From: Scala, Mary Joy
Sent: Wednesday, February 19, 2014 3:27 PM
To: Grigg, Jimmy P. (jpgrigg@dgarchs.com); Stultz, Jim
Cc: Gathright, Clark (cgathright@dgarchs.com)
Subject: BAR Action 418 17th Street NW

RE: **Certificate of Appropriateness Application (Deferred from Nov 2013)**
BAR 13-10-01
418 17th Street NW
Tax Map 9 Parcel 8
Beta Bridge, LLC, Owner/ Daggett & Grigg Architects, Applicant
Four story, 11 unit apartment addition

**CITY OF CHARLOTTESVILLE
BOARD OF ARCHITECTURAL REVIEW
STAFF REPORT
February 18, 2014**

BAR 13-10-01

Proposed West Elevation

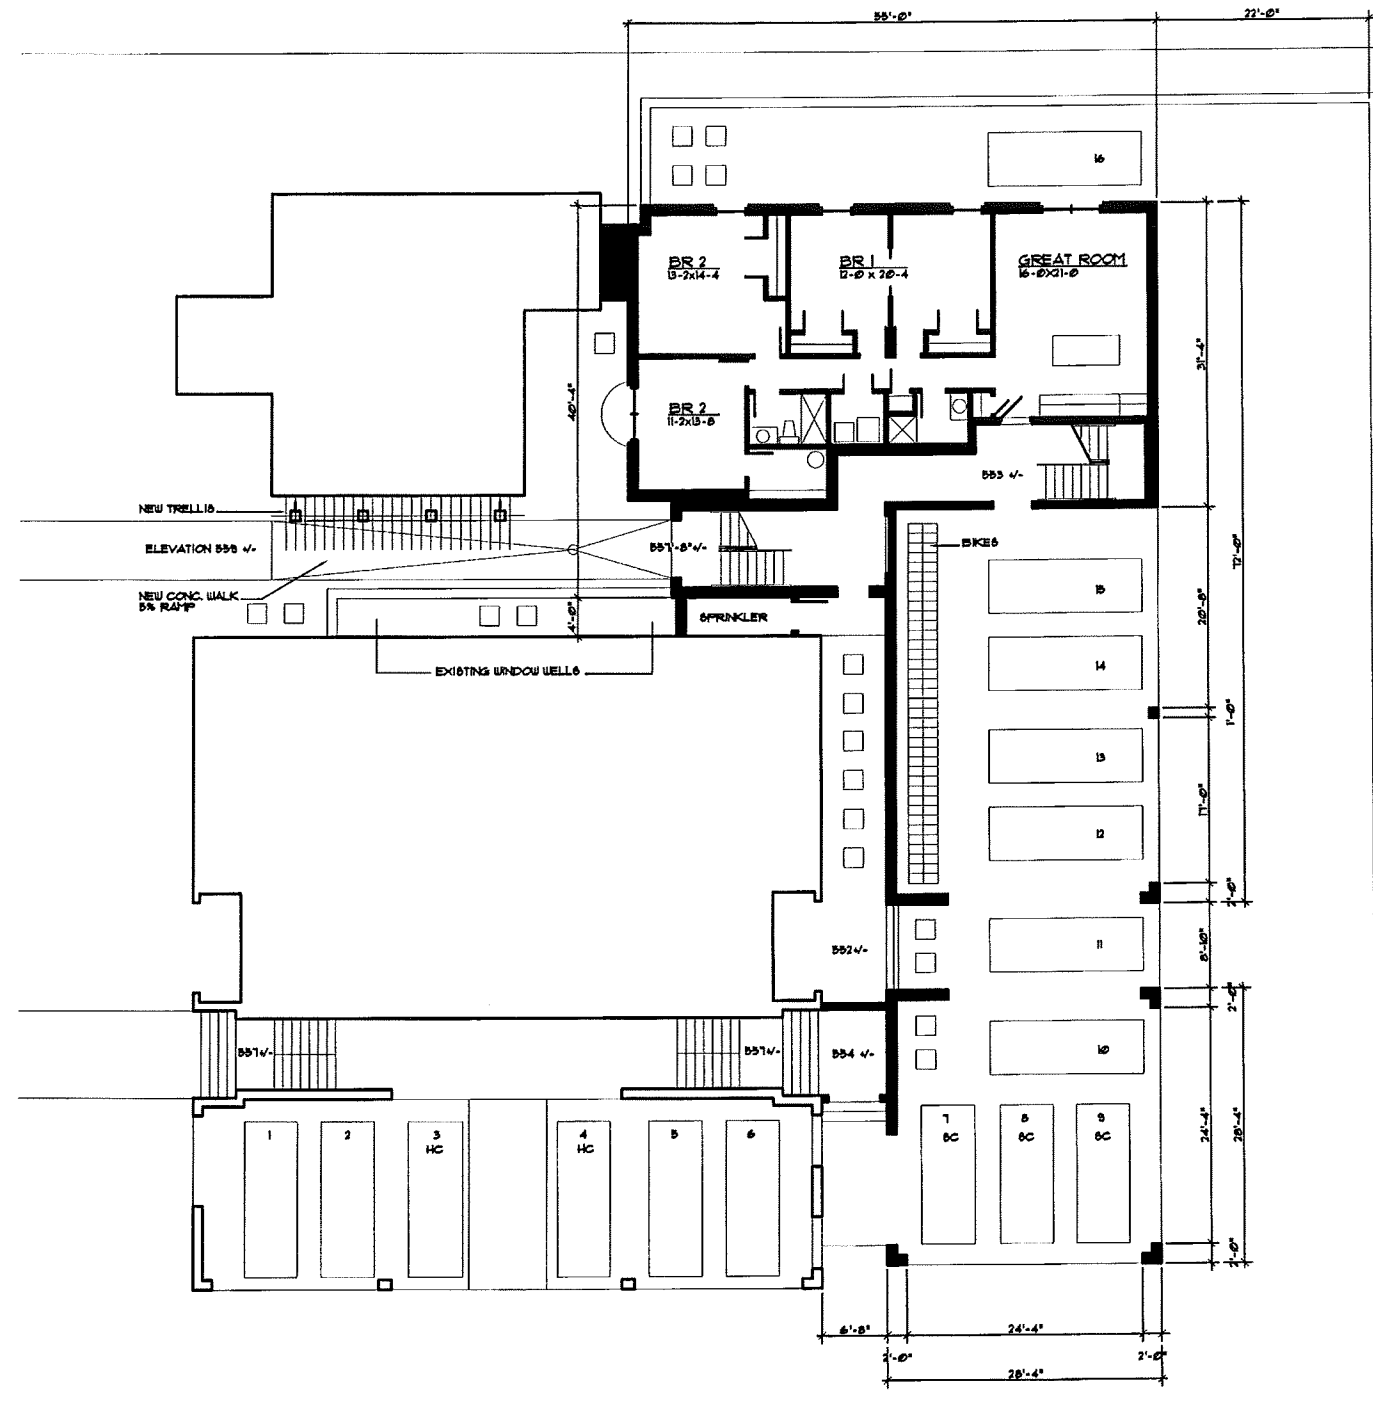
The BAR approved (8-1 with Miller against) as submitted the roof form and gable end; but not the requested change to vinyl windows (keep aluminum clad windows); and not vinyl railings; and they asked the applicant to continue to consider the entrance structure.

- Roof forms and gable ends (3-piece painted wood cornice and rake detail).
- Entry sequence between the house and existing apartment building; the pergola material should be specified.
- Change in window material from aluminum clad wood to vinyl; the material and brand of the 1/1 windows in the new addition should be specifically approved.
- The railings should preferably be aluminum or painted wood; not vinyl.
